MIL-STD-1660

NOTICE

6 June 1973

DESIGN CRITERIA FOR  
AMMUNITION UNIT LOADS

FIGURE 1 OPTIONAL ROUGH HANDLING COURSE FOR FORKLIFT TRUCKS

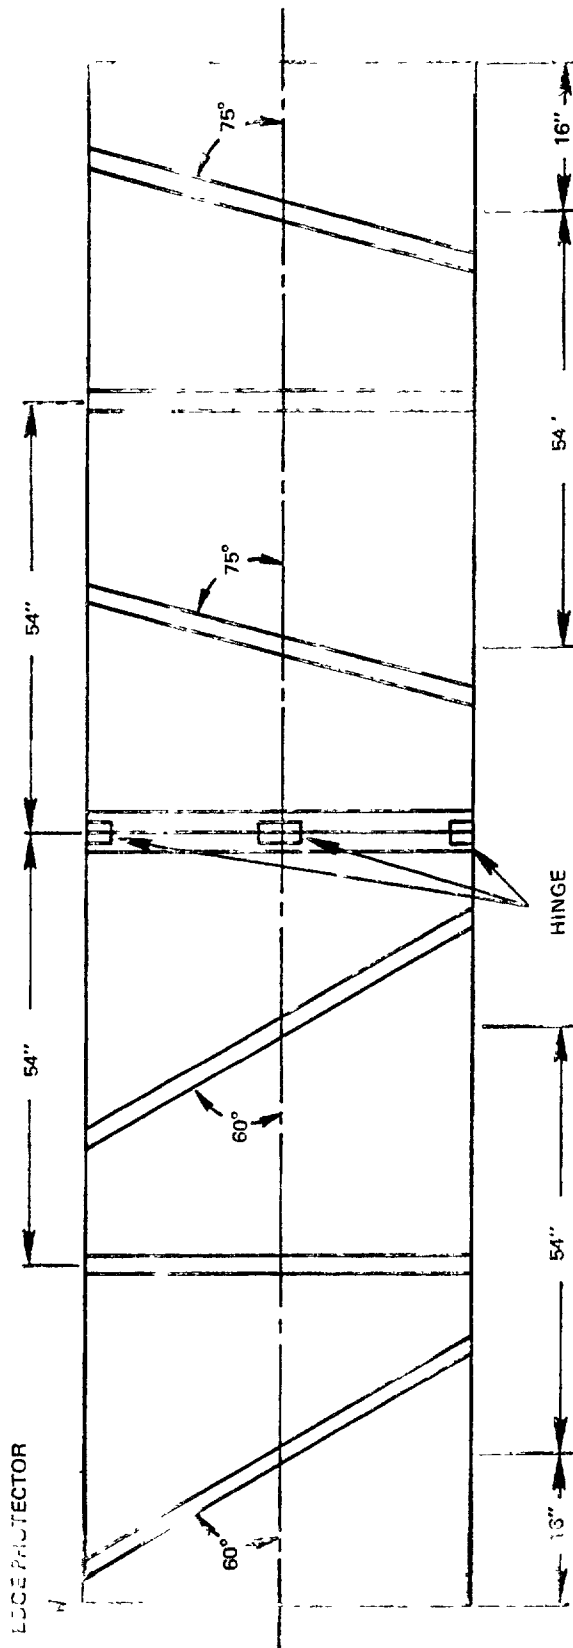
Replace existing "FIGURE 1" with new "FIGURE 1" attached.
